# Town of Brewster Planning Board

## AMENDED PLANNING BOARD MEETING AGENDA

April 12, 2023 at 6:30 PM

**TO:** Planning Board  
**FROM:** Jon Idman, Town Planner  
**RE:** Major Stormwater Permit SWMP23-10  
5 Tanglewood Road (Map 73 Parcel 86)  
Applicant, M/M Brondyk c/o JM O'Reilly & Associates, Inc.  
**DATE:** March 29, 2023

EXISTING CONDITION PLAN  
 LOT 7 RUN HILL ROAD, BREWSTER, MA

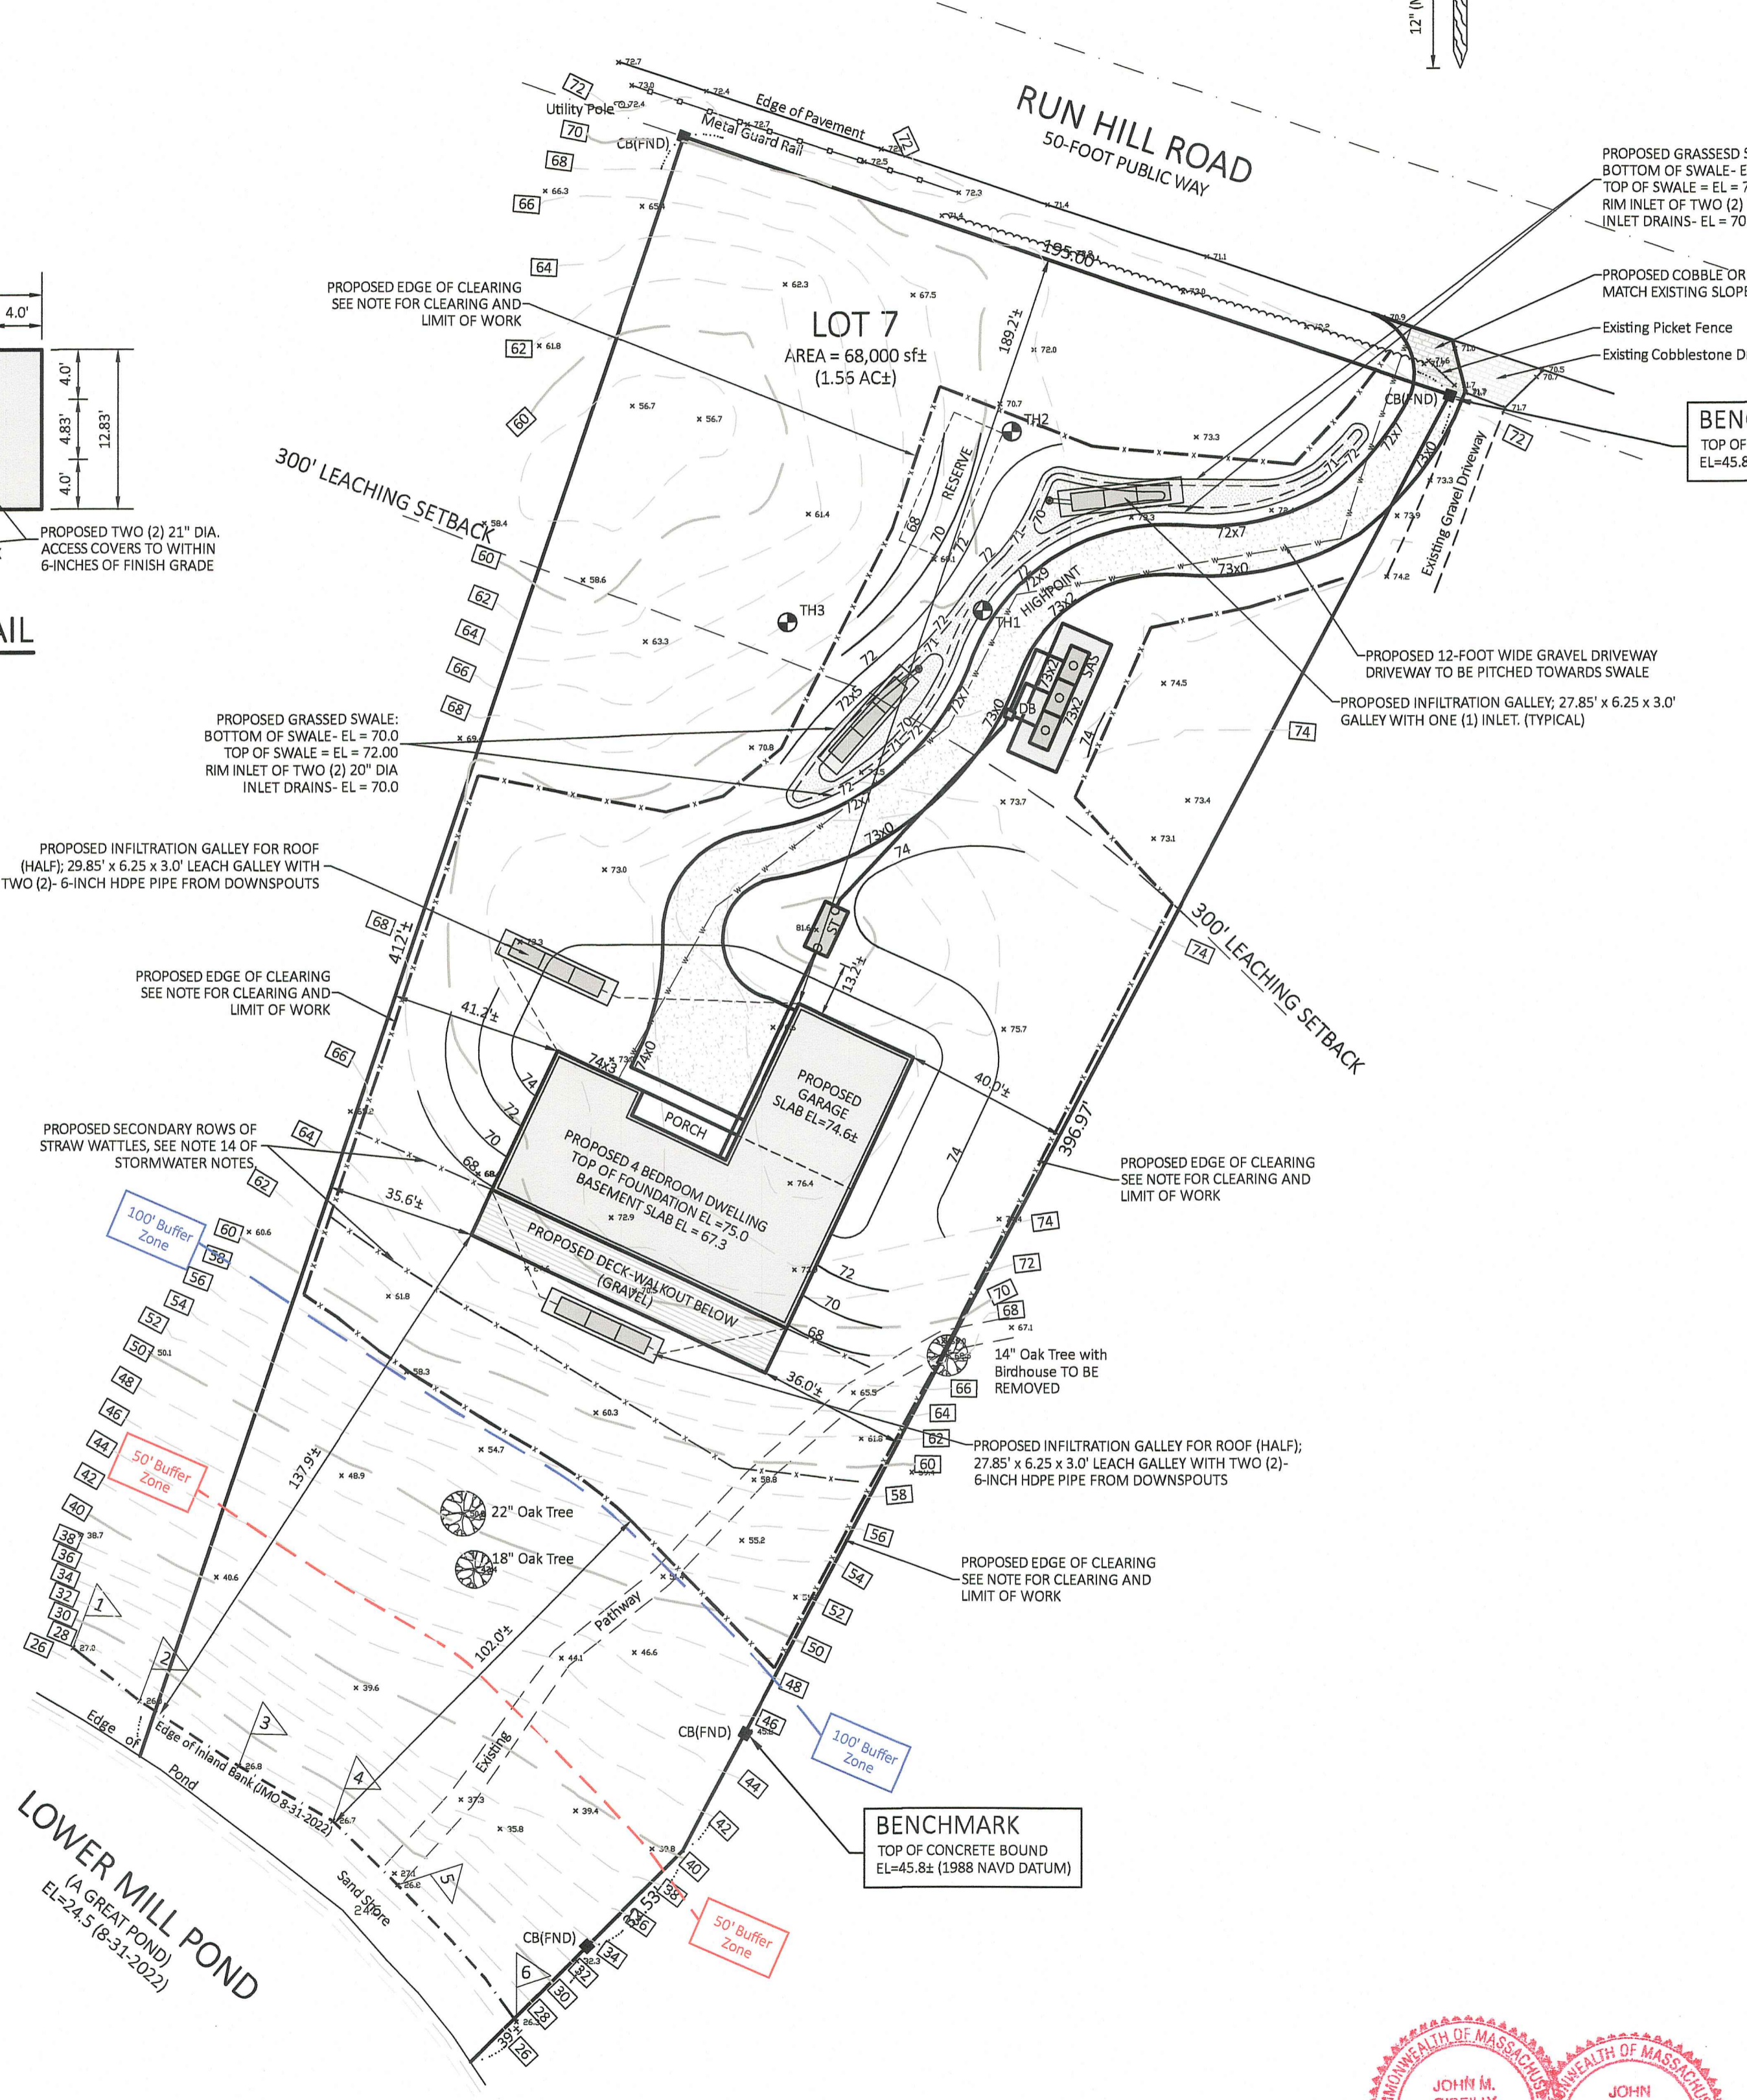
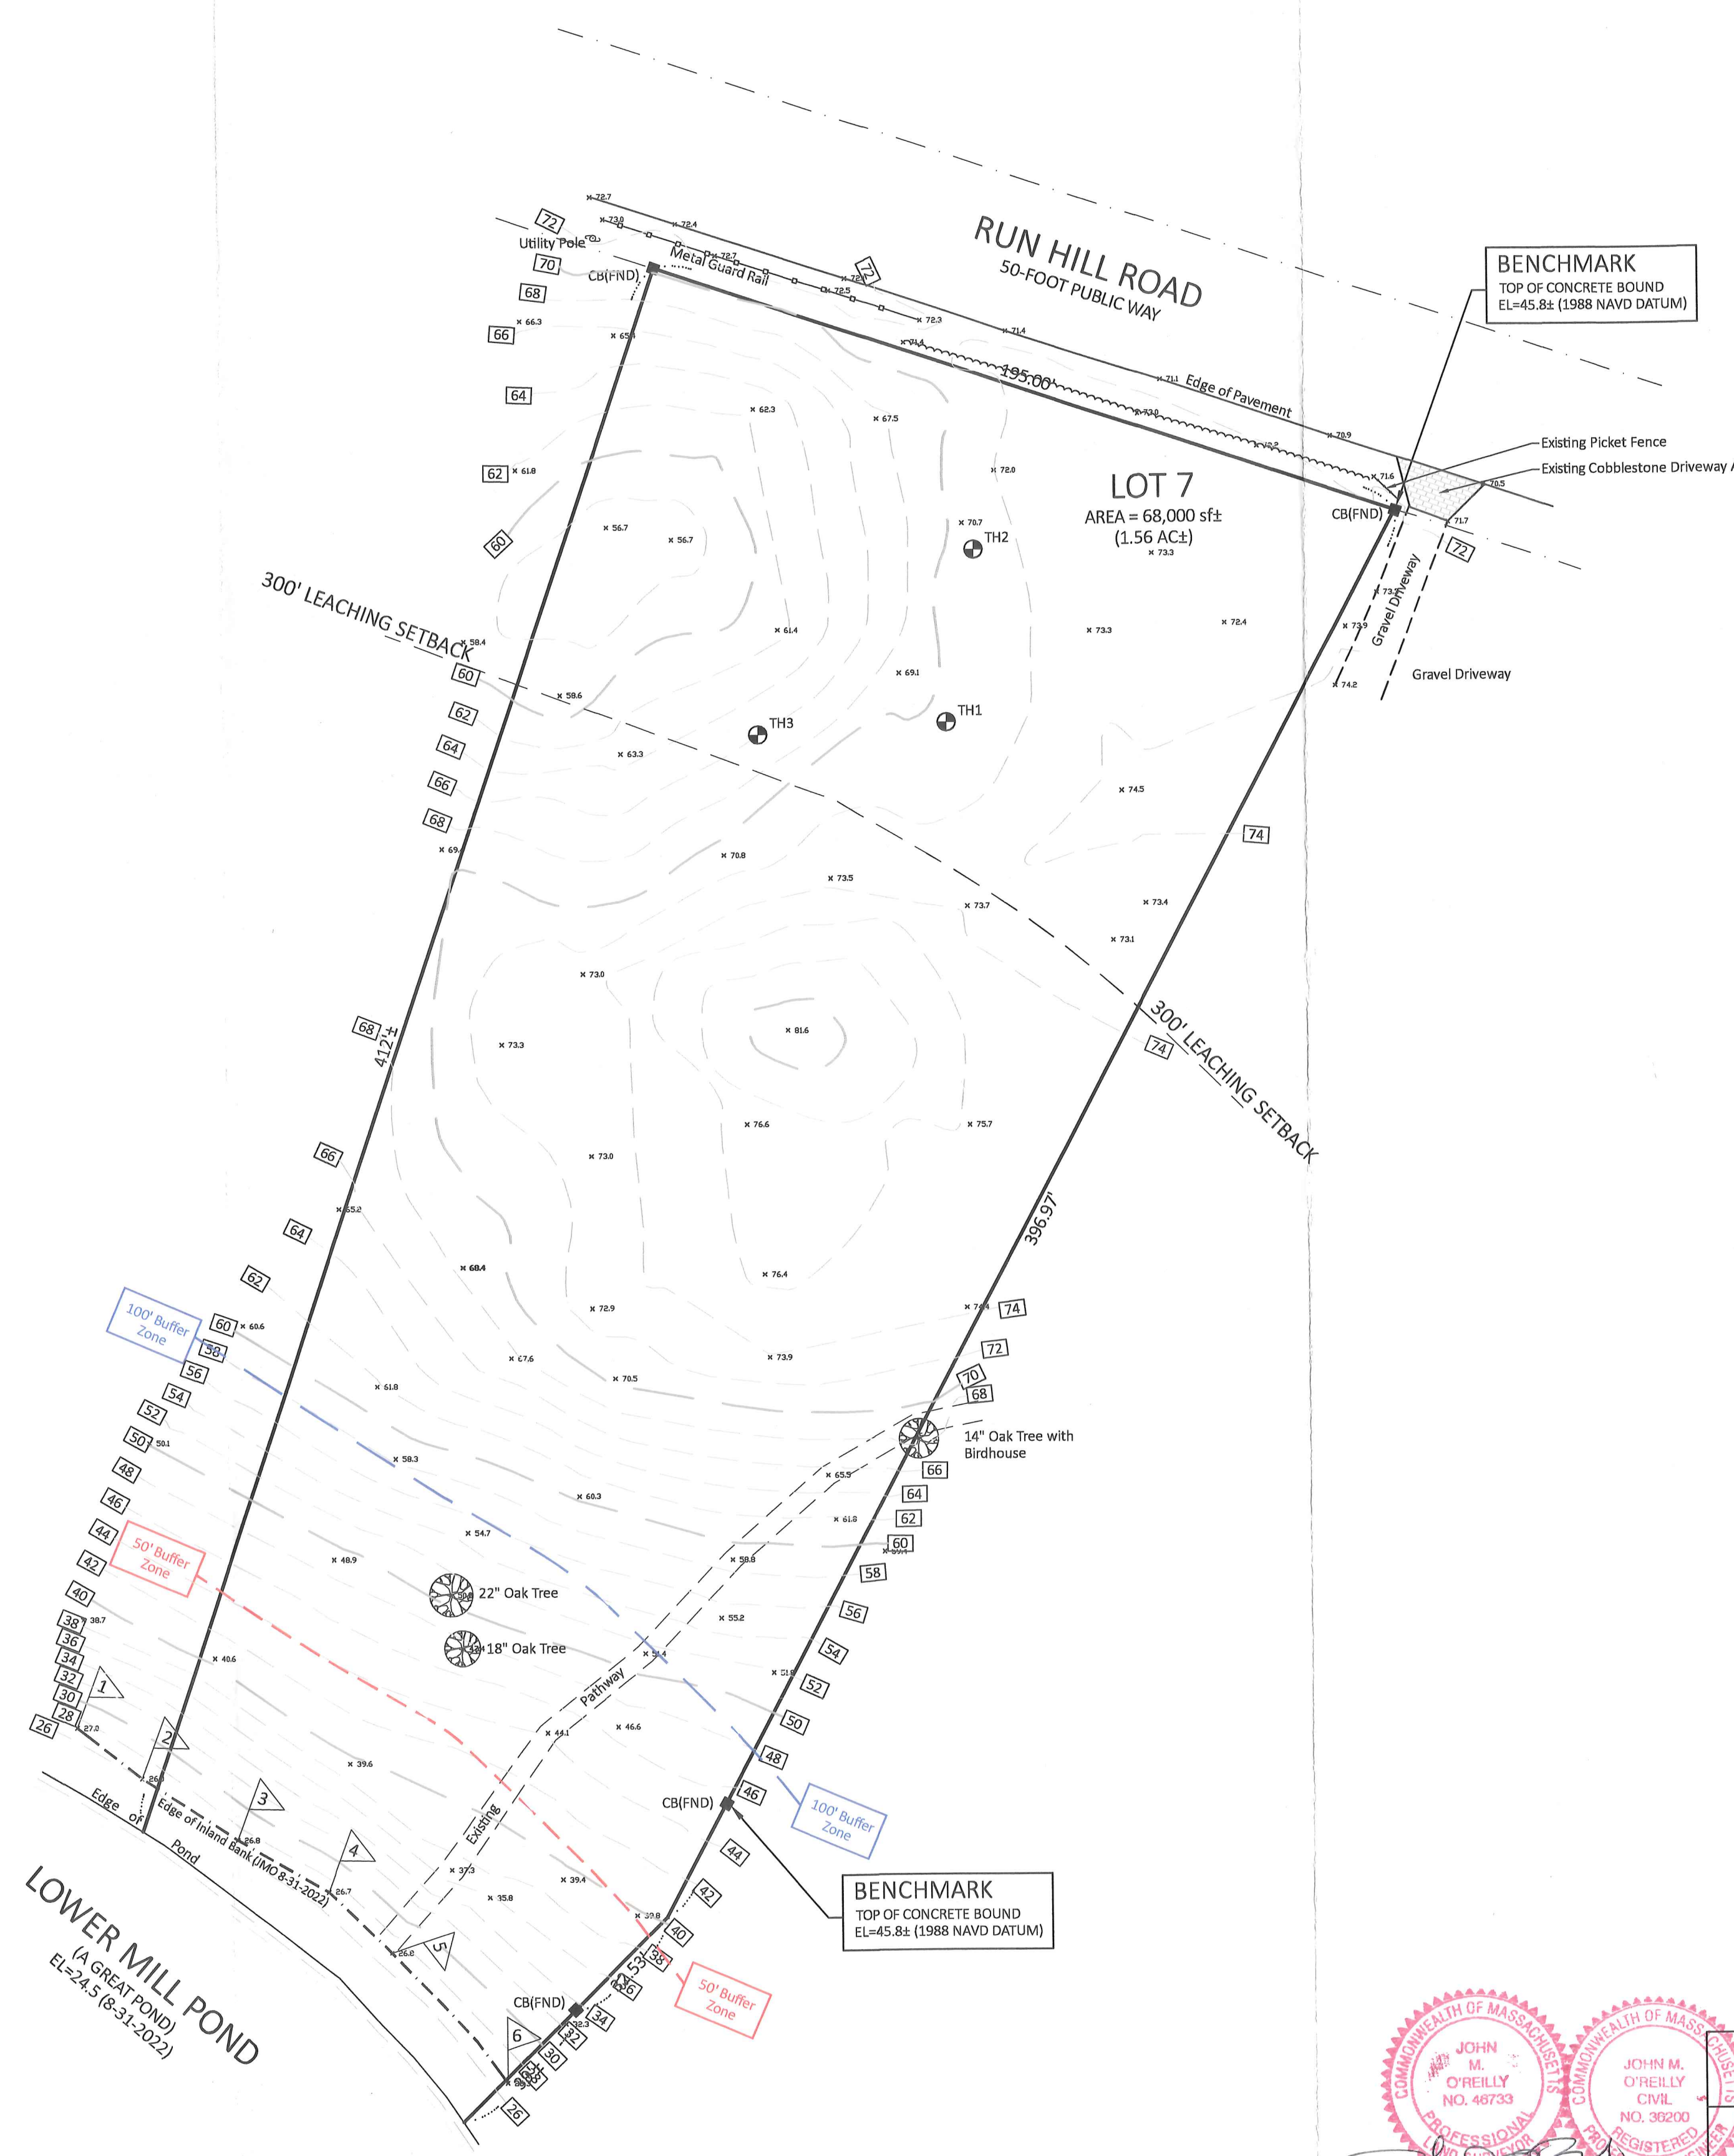
The Applicant has provided the required application materials for a Major Stormwater Permit, including a site plan (revised 3/27/23) and Stormwater Management and Hydrologic Report (dated/ stamped 3/22/23), as set out in Appendix B of the Stormwater Management Regulations.

- Proposed Site Plan entitled "Mr. Christopher Platts, 1 Partridge Lane, Littleton, MA 01460, Sewage & Stormwater Site Plan, Lot 7, Run Hill Road, Brewster, MA," prepared by JM O'Reilly & Associates, Inc., revised dated 3/27/23 and stamped by John M. O'Reilly, PE, PLS.

The Applicant has provided construction-period BMPs in an erosion and sedimentation control plan consistent with the performance standards for Major Stormwater Permits set out in Section 6.1B of the Stormwater Management Regulations. Plan elements include straw wattles, a gravel construction drive

The post-construction stormwater management system for the site consists of three separate stormwater management subsystems/ catchment areas. Roof run-off will be collected separately from site run-off, then directed to one of the subsurface leaching facilities for recharge; there is a system for each the front and rear halves of the proposed residence. Run-off from the gravel driveway will be conveyed by grass channel, collected from sheet flow, then directed to a grass swale and then to two subsurface leaching facilities. There is also a natural depression in the northeast portion of the site, proposed to remain unaltered, which will assist in collecting, infiltrating and treating stormwater. The Applicant has provided a corresponding Operations and Maintenance Manual. These post-construction BMPs are consistent with the Major Stormwater Permits performance standards for new construction set out in Section 6.2B and Section 8.2 of the Stormwater Management Regulations:

Approval should be granted subject to the continuing obligations set out in said Regulations, including Sections 5.7, 5.8, 5.9 (Certificates of Compliance), 6.1B (Construction practices), Section 7.2 (Inspections), 8.3 (Recording of stormwater permit and O&M plan) and 8.5 therein.
